**PALM BEACH COUNTY
PLANNING, ZONING AND BUILDING DEPARTMENT
ZONING DIVISION**

Application No.: DOA/R-2014-00649
Application Name: Turnpike/Exit 93 MUPD
Control No.: 2003-00025
Applicant: Turnpike Realty, Inc
Owners: Turnpike Realty, Inc.
Agent: Jon E Schmidt & Associates - Josh Nichols
Telephone No.: (561) 684-6141
Project Manager: Joyce Lawrence, Site Planner II

TITLE: a Development Order Amendment REQUEST: to reconfigure the Site Plan; add a Requested Use; and, to modify/delete Conditions of Approval (Engineering, Landscaping, and Sign). **TITLE:** a Requested Use REQUEST: to allow a Type I Restaurant.

Figure 4 - Preliminary Site Plan dated August 19, 2014

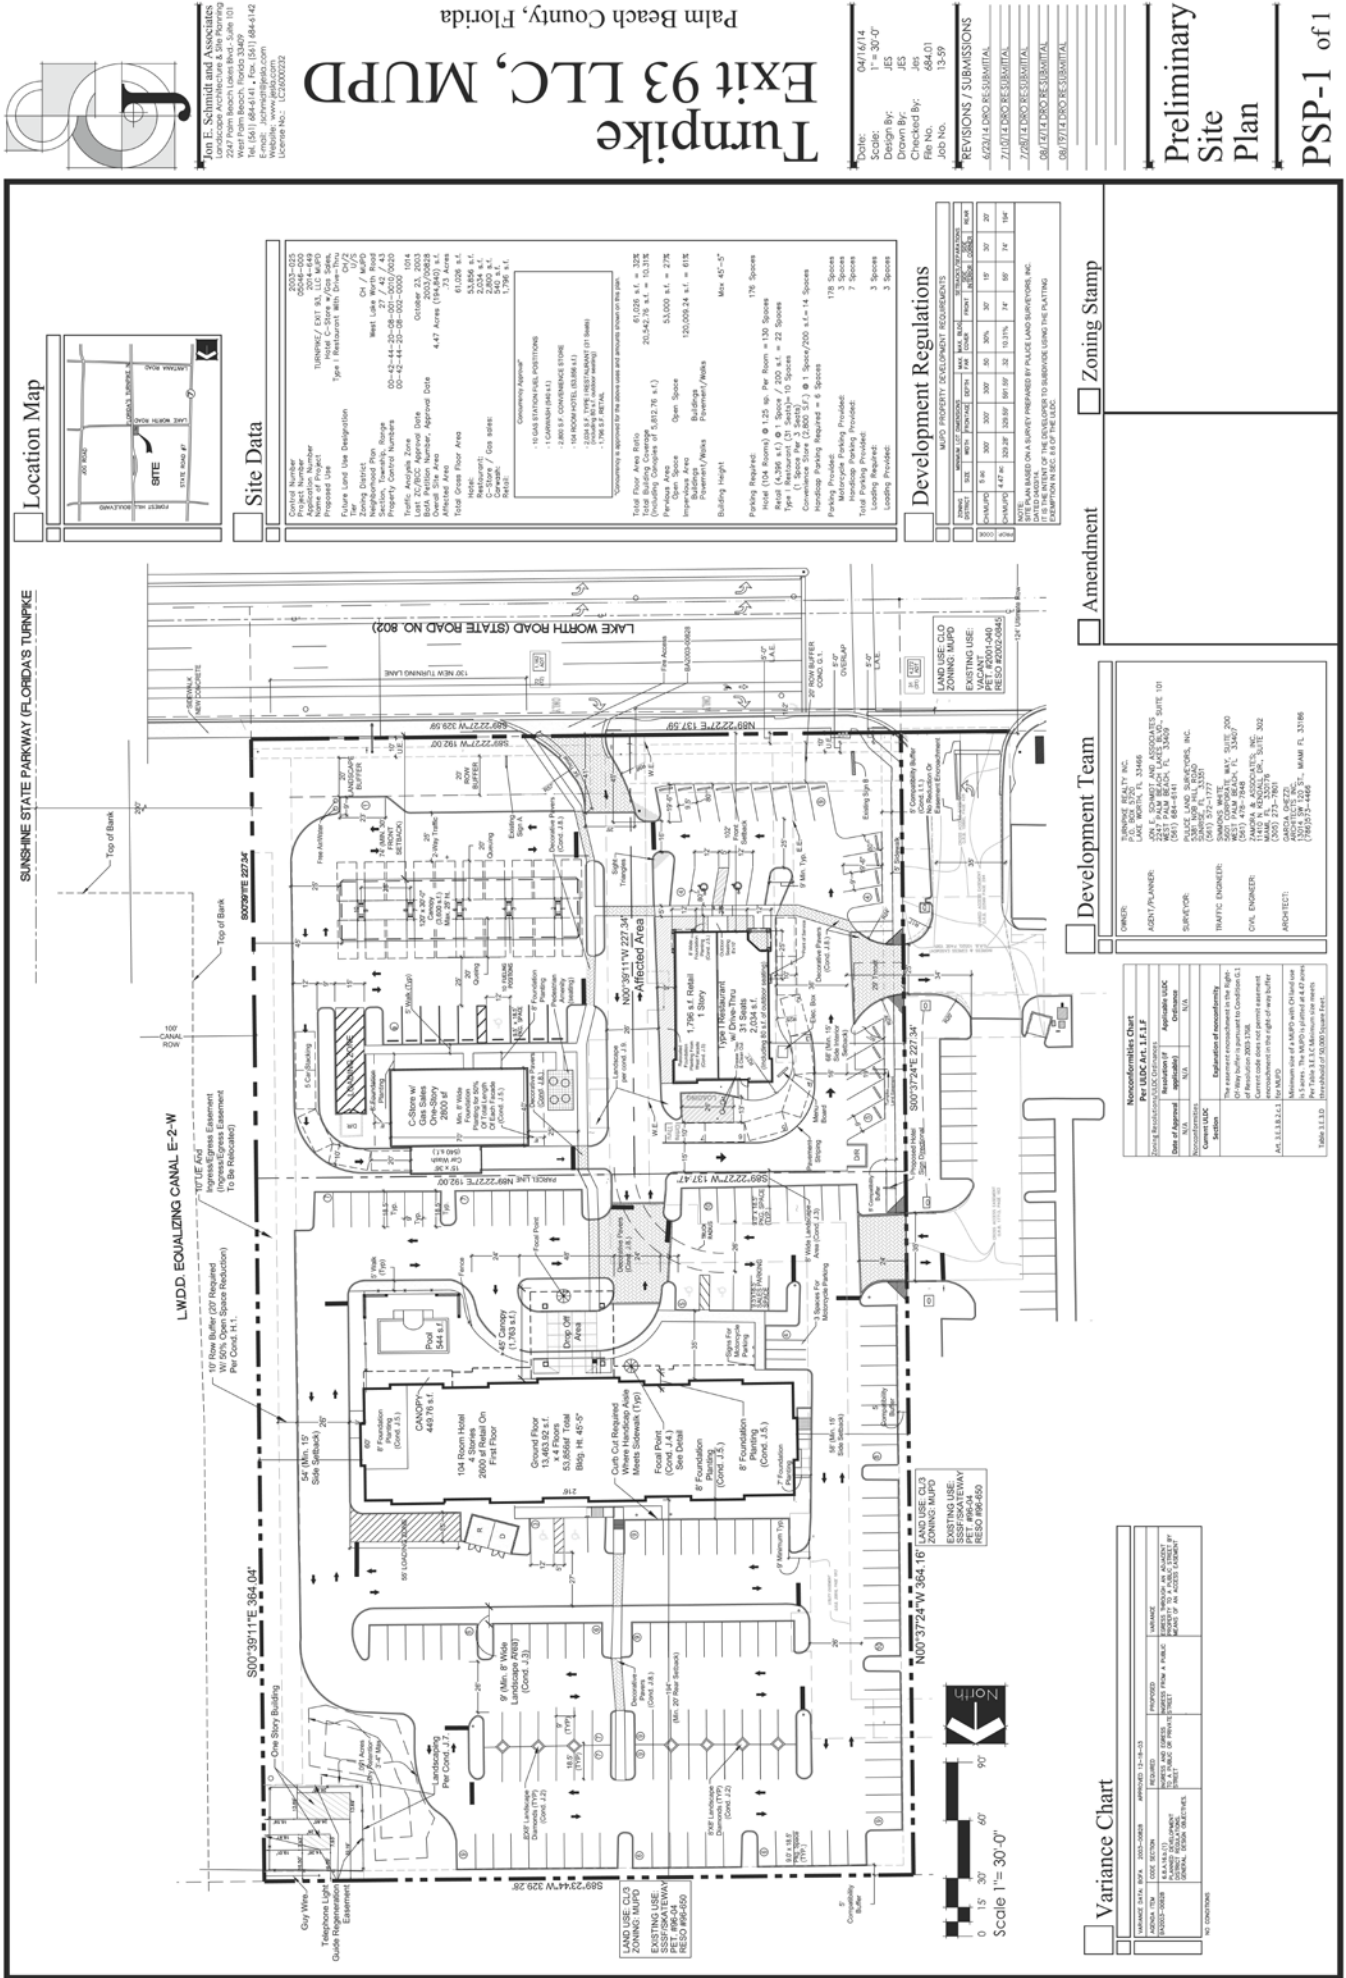
Parking: The prior approval required 181 spaces, the approved Plan showed 183 spaces. With the proposed reconfiguration and change in uses, a total of 176 parking spaces is required and the Applicant is providing 178 spaces. Even though there is a reduction of spaces from the prior approval; however, because the subject property is an MUPD, the ULDC allows a range of parking spaces from 4 spaces/1000 sq. ft. to 6 spaces/1000 sq. ft. The current proposal meets the ULDC requirements.

Loading: At time of submittal for final Site Plan approval by the Development Review Officer (DRO), the Applicant will be requesting a Type I Waiver to reduce the dimensions of the loading area. Pursuant to the ULDC, Article 6.B.1.H, Dimensional Standards, the required loading space shall be a minimum width of 15 feet and minimum length of 55 feet. The Applicant is proposing a reduction to a dimension of 13 feet x 26 feet, and is seeking approval through the DRO process.

Landscaping: In accordance with ULDC, Article 7.D.11, the Applicant is proposing to relocate the required Foundation Planting from the west façade of the Restaurant to the entire east façade. However, Staff is recommending that, at time of submittal for Final Site Plan Approval by the DRO, the Applicant shall revise the plan to relocate the required (40% at a minimum of 8 feet wide) Foundation Planting for the west facade to the north facade of the building. No change is proposed to the existing perimeter buffers. The 20-foot wide Right-of-way Buffer has an existing 5-foot Utility Easement encroachment, but and is addressed under Non-Conformities chart on the Preliminary Site Plan.

Signage: Staff recommends that at time of submittal for Final Site Plan Approval by the DRO, the Applicant shall revise the Site and Master Sign Plans to indicate the location of the On-Site Directional and the "Do Not Enter" Signs. The signs are to show directions and facility information including on-site services and to ensure safety of the patrons.

The Applicant is proposing to redesign the site by reconfiguring the parking area to accommodate a drive through lane for the proposed Type I Restaurant. The proposal should not create any additional adverse effects, including visual impact and intensity of the use on adjacent lands.

1. Prior to final approval by the Development Review Officer (DRO), the Site Plan shall be revised to indicate the following:

- a. a minimum of eight (8) feet wide foundation planting along the north side of the Type I Restaurant Building; and
- b. the length shall be no less than forty (40) percent of the total length of the north side of the Type I Restaurant Building. (DRO: LANDSCAPE - Zoning)
